GE Energy
Nuclear

NEDE-33299
Class I
eDRF 0000-0062-4772
December 2006

LICENSING TOPICAL REPORT

Advanced Boiling Water Reactor (ABWR) With Alternate RCIC Turbine-Pump Design

Figure 2: Typical Start Transient

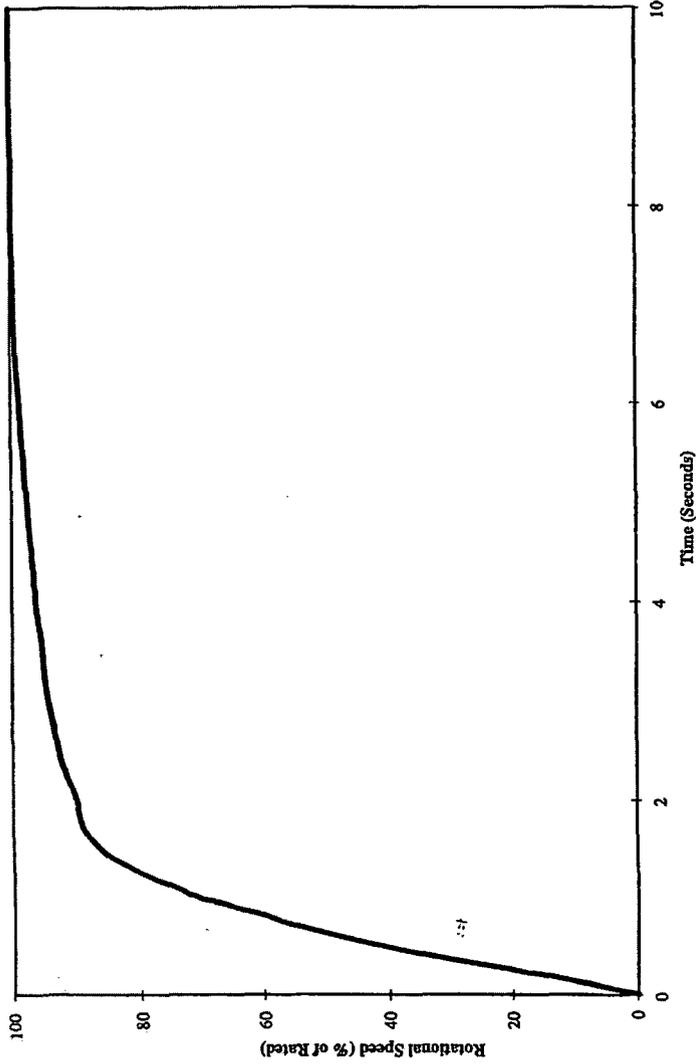
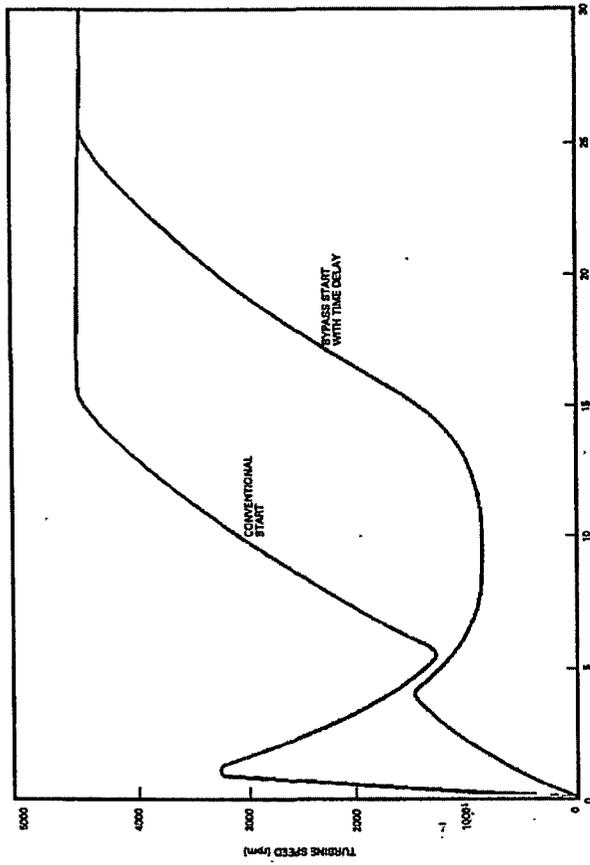
- 3.5 Start Transients The normally open control valve in the alternate design operates quickly in response to the pressure differential to adjust the steam flow to the turbine in the required amount to allow the pump to provide the required water flow rate to the reactor pressure vessel. A typical transient is smooth and achieves the full rated speed and flow in approximately 10 seconds. Typical start transient is shown in figure 2. In contrast, the bypass starting option in the DCD design with its associated complex controls, which adds complexity to the system from present design, is eliminated in the alternate (TWL type) design and further simplifies the RCIC System design.

With the DCD design, the normally open governor valve reacts to the initial steam entry through hydraulic actuation. A shaft driven pump provides the pressure for the actuation. To provide time for the hydraulic pump to provide actuator control and to prevent initial start up speed transients, a small steam bypass is provided in the steam supply line. The turbine is brought to an idle speed, which allowed it to stabilize. A command is then given to open the main steam admission valve to permit turbine to increase speed based on an electronic ramp signal. When the bypass has been open for approximately 10 seconds, the main steam valve is opened and speed is increased to achieve rated flow within a maximum time of approximately 30 seconds. Typical start transient for this system is shown in figure 3. The curve labeled "conventional start" is the idealized start transient without the steam bypass.

This start has been shown to result in an over speed trip if there is any delay in the control valve movement during the initial startup. The control valve stem sticking caused from stem and packing corrosion further exacerbates an over speed trip. This caused excessive non-representative frictional force in the valve stem kinematics, resulting in valve opening delay. The alternate (TWL type) turbine-pump design provides turbine protection on "over-speed", based on the 120 % (maximum) of rated speed limit with a mechanical trip design as well as a an electronic over-speed trip which automatically shuts down the turbine upon receipt of any signal indicating turbine over-speed at 115% of rated speed.

Figure 2.4.4a Reactor Core Isolation Cooling System

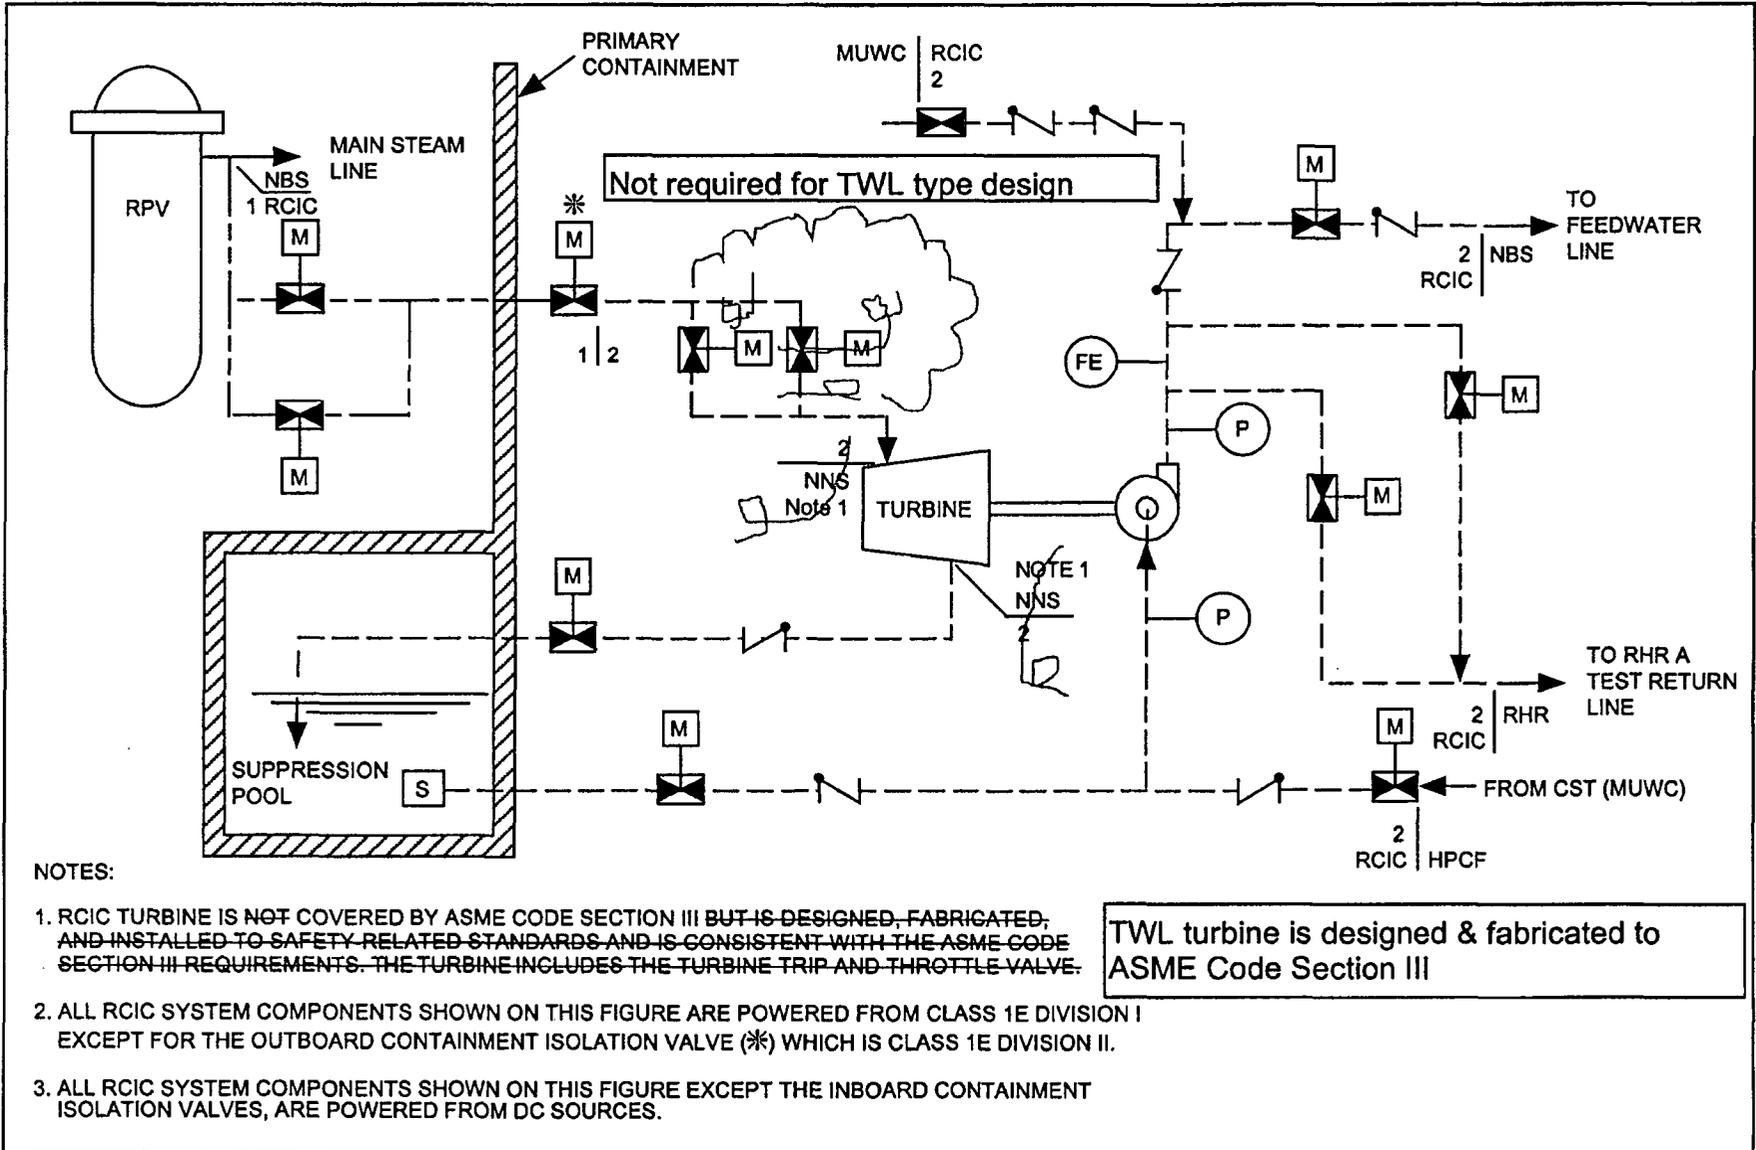
The revision to figure 2.4.4a will delete the steam bypass valve. Further, note 1 is restated to show compliance with ASME Code Section III for the turbine and the ASME Code and safety classification breaks at the turbine inlet and outlet are removed.
